Proposed Amendments to Enhanced Vapor Recovery Regulations

5 May 2020 Workshop

By Ted Tiberi, ARID Technologies, Inc.

13 May 2020

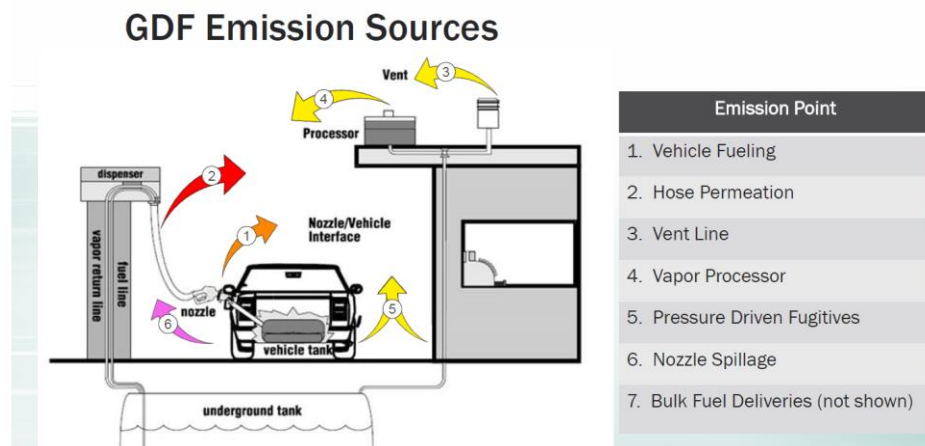
With reference to below schematic presented by ARB during the Workshop, we note seven emission points listed, and six vapor emissions points highlighted. As ARB realizes, the emissions shown can be categorized into **Refueling Emissions** and **Storage Tank Emissions**. The majority of the emissions from Refueling can be characterized by point 1, and these emissions are dependent primarily on ORVR and Phase II nozzle vapor recovery efficiency. The majority of the Storage Tank Emissions can be characterized by points 3 and 5 (neglecting for now, the presence of a processor), and are primarily dependent upon storage tank pressure, which in-turn is dependent upon fuel evaporation rate (and leak rate) within the combined storage tank ullage space. The total emissions from a given GDF must include the sum of the Refueling Emissions and the pressure related Storage Tank Emissions. Even if the “front-end” combination of Phase II and ORVR refueling technologies yields high vapor recovery efficiency, the loss of vapors from “back-end” storage tank emissions must be included in the overall vapor recovery efficiency. Even relatively small mass emission rates from the storage tanks can negatively impact overall vapor recovery efficiency.
